Product Change Notification

Change Notification #: 110610 - 00
Change Title: Intel® Desktop Board DQ67OW, Boxed and Bulk
PCN 110610-00, Product Design
BIOS Update and Change to Capacitor to Improve Power Margins
Date of Publication: May 06, 2011

C634 Location on PCB

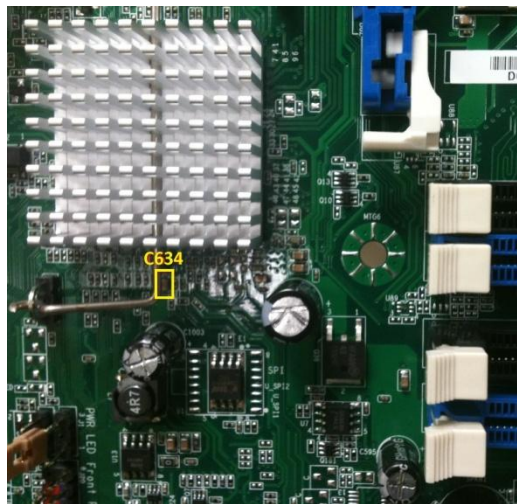
1. BIOS update from SWQ6710H.86A.0041 to SWQ6710H.86A.0049. To access the release notes or get a copy of the BIOS for evaluation, go to <http://downloadcenter.intel.com>.
2. Change capacitor C634 from 10uF to 47uF to improve power margin.
